Density Update Request: Add Additional Residential Density

Removing Roads Request: Evaluate Road Layout for Townhomes and Western Buffer Impact

Affordable Housing Update Request: Evenly distribute affordable housing across all housing types

S Columbia Street Crossing Three options:

Previous (April 19th) Site Plan (for reference)

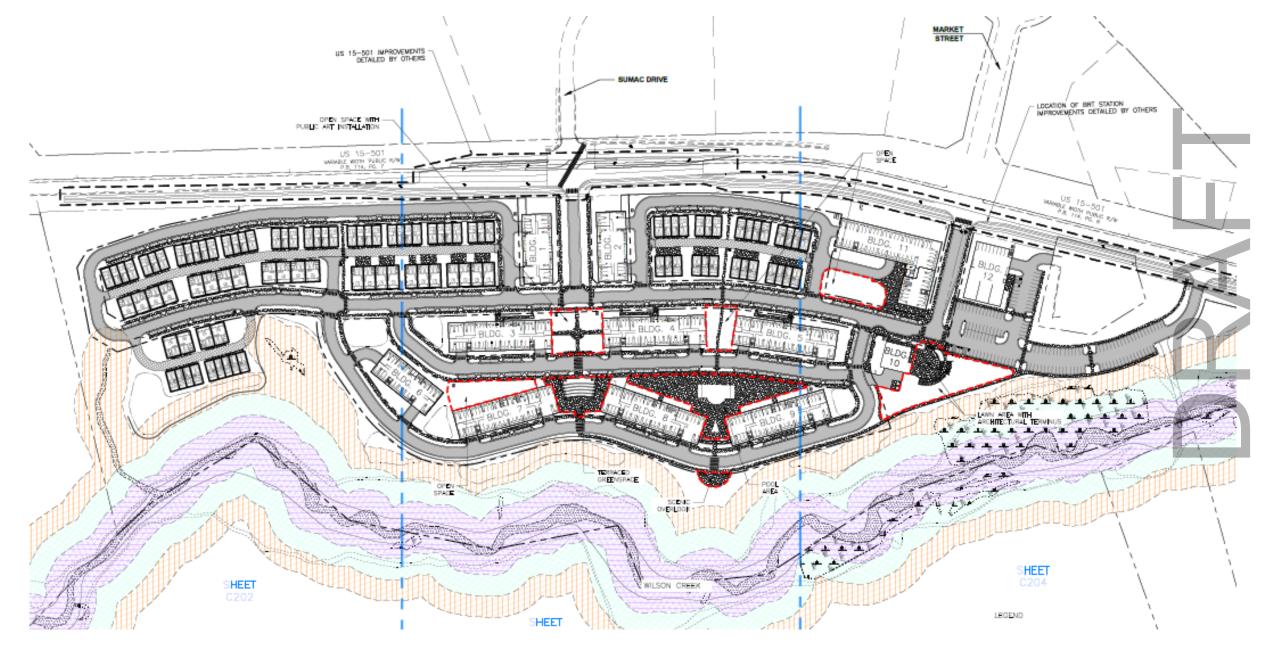
APRIL 19th	April 19th
Rental (Apartment)	60
Condos	526
<u>Townhomes</u>	<u>102</u>
Total	688
Affordable homes included in the above number:	88

LOWER RANGE	June 7th	UPPER RANGE	June 7th	Change
Rental (Apartment)	60	Rental (Apartment)	120	+60
Condos	526	Condos	606	+80
<u>Townhomes</u>	<u>102</u>	<u>Townhomes</u>	<u>89</u>	-13
Total	688	Total	815	+127
Affordable homes included in the above number:	88	Affordable homes included in the above number:	105	+13

Review of Alternative # 2: Convert Alley to Public Rd

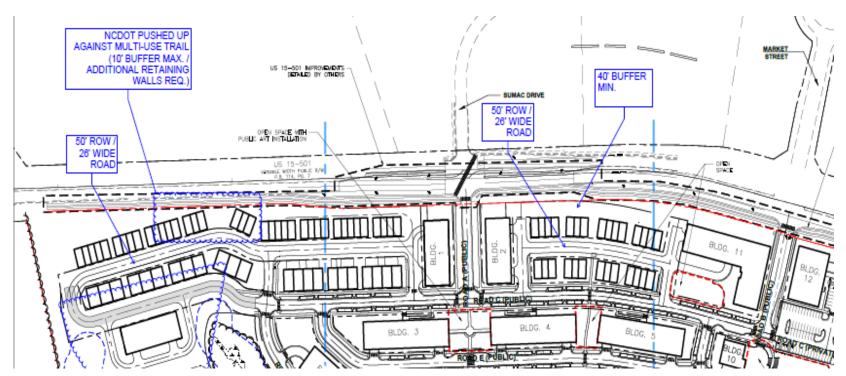
- Eliminates most roadway
- Larger buffer area, but still varies from 5' to 40'

- Least # of units (84 or 78 to increase buffer)
- Front doors likely to be slightly below grade
- Garage front homes
- Crowded streetscape vehicles, utility pedestals, etc.

NOT RECOMMENDED

Aerial View - East

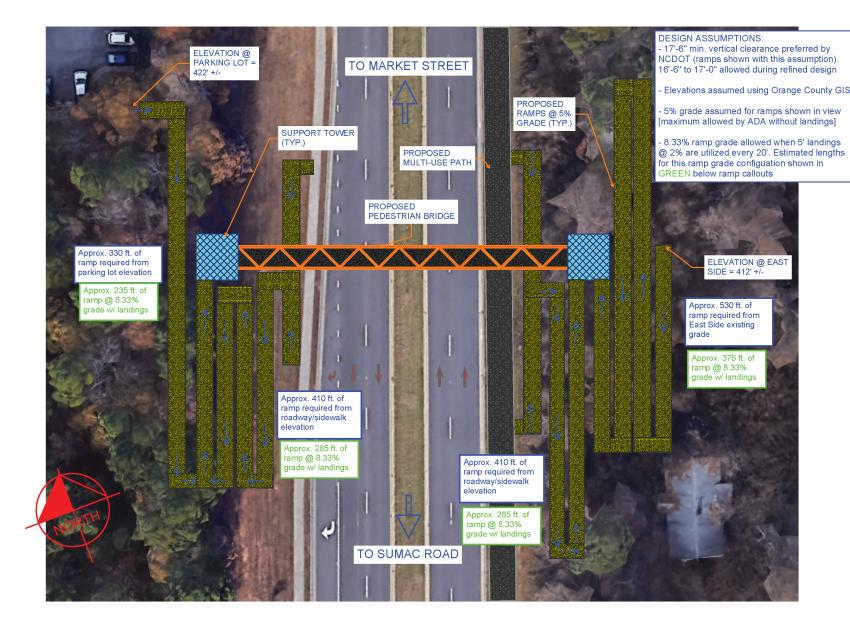
CHALLENGES WITH A PEDESTRIAN BRIDGE:

The topography drops significantly as you move from west to east across 15-501, by as much as **20 feet** from one side to the other. To maintain truck height clearances over the road, the bridge would be very high on the South Creek side.

- This means that stairs up to the bridge would require pedestrians to climbs as much as 20 feet of stairs.
- Ramps would also be required for ADA and bicyclists. Climbing the height needed would require thousands of feet
 of ramp. On the South Creek side alone we estimate that it would be up to 1,125 feet of ramp.

- Elevators could be built, but this would further increase the already high cost.
- The land needed for additional ramping may eat into developable land and reduce South Creek density

- This is not an optimal solution for children nor does it encourage true connectivity
- 2. TRAVEL TIME & SAFETY: The stairs and ramping result in a travel time across the bridge of an additional 30% longer than crossing at grade. We believe this may discourage use of the bridge and many people may try crossing at grade instead.

- 3. COST: The renderings of the bridge is from a similar bridge being built in Elizabeth City, NC. Cost estimates for that bridge are \$11-\$14MM, and we believe a bridge here would be equally if not more expensive due to temporary relocation of 15-501.

CHALLENGES WITH A PEDESTRIAN TUNNEL (Continued):

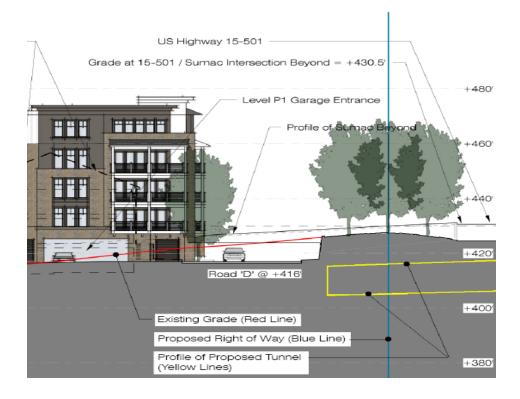
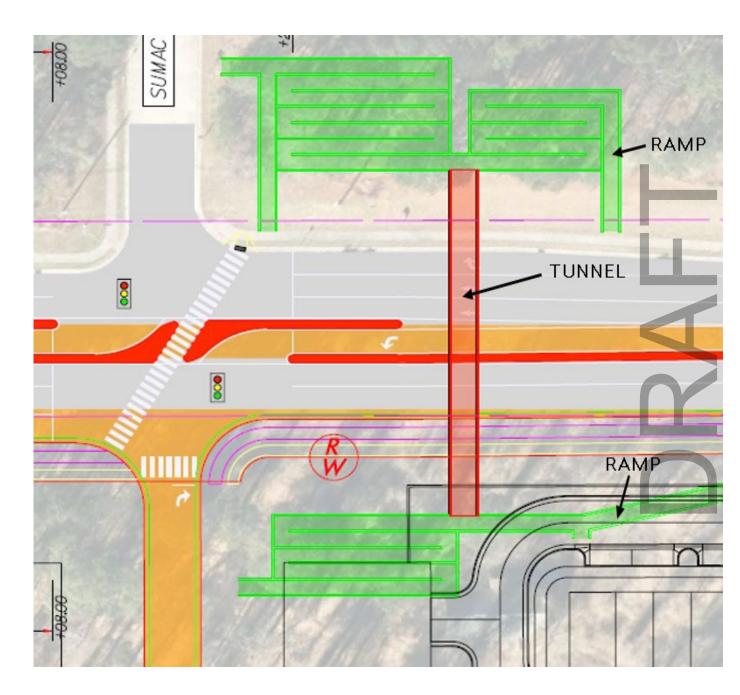
This sketch illustrates (in green) the ramping required on both sides of the pedestrian tunnel. The tunnel itself is shown in red.

The image below is a cross-section of the pedestrian tunnel highlighting the differences in grade:

CHALLENGES WITH A PEDESTRIAN TUNNEL (Continued):

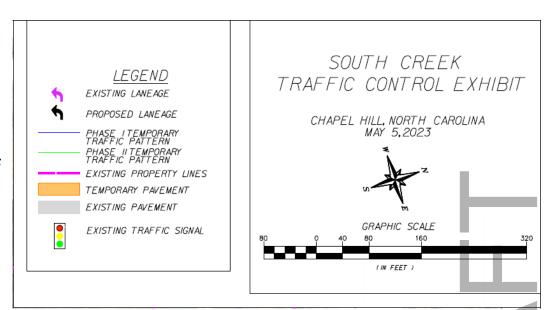
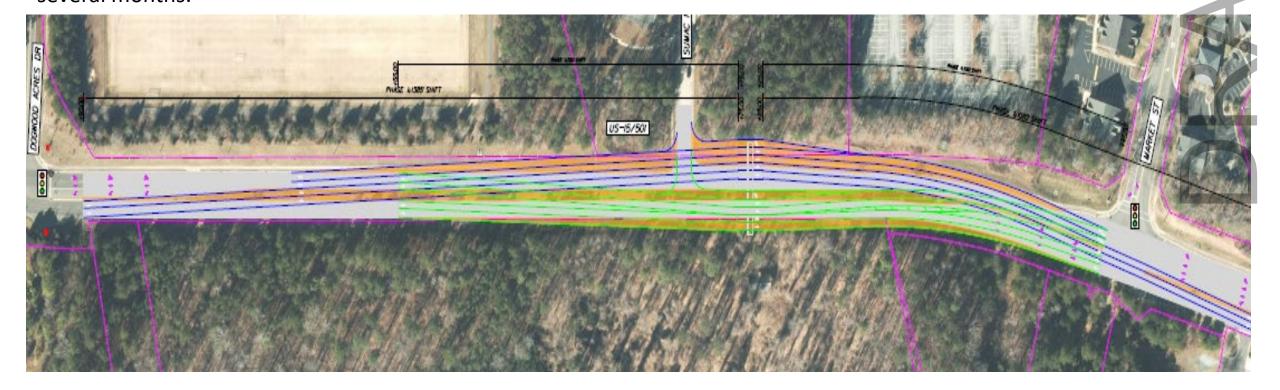
TUNNEL WOULD REQUIRE EXTENSIVE WORK TO 15-501: Construction of a tunnel would require extensive re-routing of 15-501 to create temporary lanes during construction (estimated +2,000 feet). Additionally, the OWASA water line and other utilities would need to be relocated. The dislocation and restoration of 15-501 would take several months.

S Columbia Street Crossing Bridge and Tunnel Options

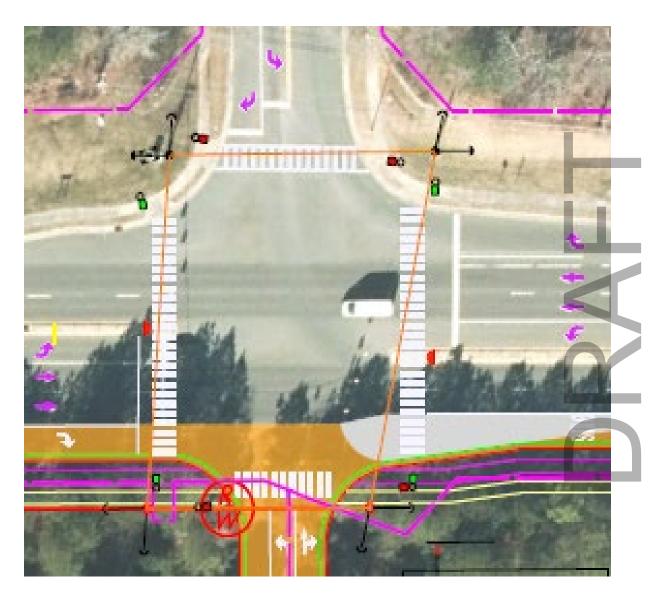
ADDITIONAL CHALLENGES WITH A BRIDGE AND TUNNEL:

- 1. DOT Approval Required but not guaranteed. DOT may not allow for the proposed leftover movement should a bridge/tunnel be pursued.
- 2. **Timeframe:** Construction of either a bridge or a tunnel would take considerable time and likely disrupt local businesses and traffic on 15-501, a major artery. This could delay the completion of the new housing units or potentially drive away potential home buyers.

- **3. Maintenance and Upkeep:** The initial cost is only part of the cost. Ongoing maintenance costs will be substantial over the long term, and if that cost is borne by residents, could lead to higher than expected HOA dues.

- **4. Lower Affordability:** The costs of a bridge or tunnel will ultimately be passed onto residents of South Creek in some form, either higher purchase prices or higher rents, and impact the affordability of the units. This works against our goal of building affordable housing.

- **5. Safety & Connectivity**: To truly encourage safe connectivity for school children, bicyclists and residents, crossings should minimize travel time, be accessible and visually appealing. The significant ramping, bridge height and dark tunnel discourage true connectivity and do not present the best safety features offered by a short signalized at-grade crossing.

Aerial Rendering of Market crossing

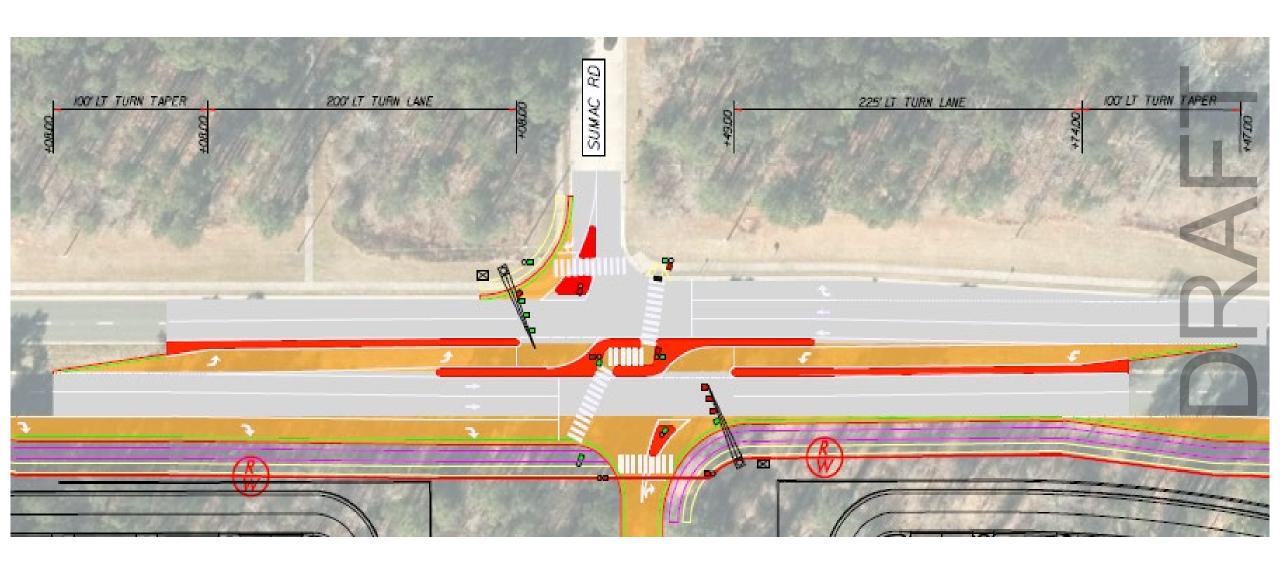
- Fully Signalized Intersections @ Sumac Rd and Market St
- Sumac functions as primary pedestrian crossing location
 - Increased Pedestrian Signage
 - Staggered Refuge Area, colored brick/paving
 - Pedestrian Signal Heads
 - Traffic Stop Buffer
- Market crossing remains as proposed
